Engineering Change Notification

NHD-4.3-480272EF-ASXN#
NHD-4.3-480272EF-ASXN#-CTP
NHD-4.3-480272EF-ASXN#-T

NEW TFT

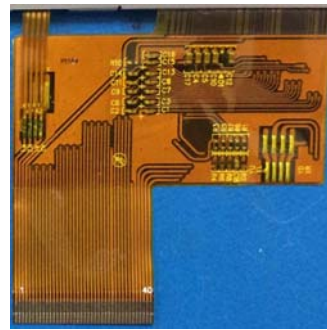
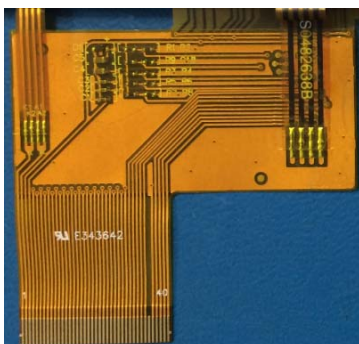
The built-in TFT driver has been changed from Himax HX8257-A to [Sitronix ST7282T2](#).
TFT FPC has also been redesigned to match the new driver's requirements.
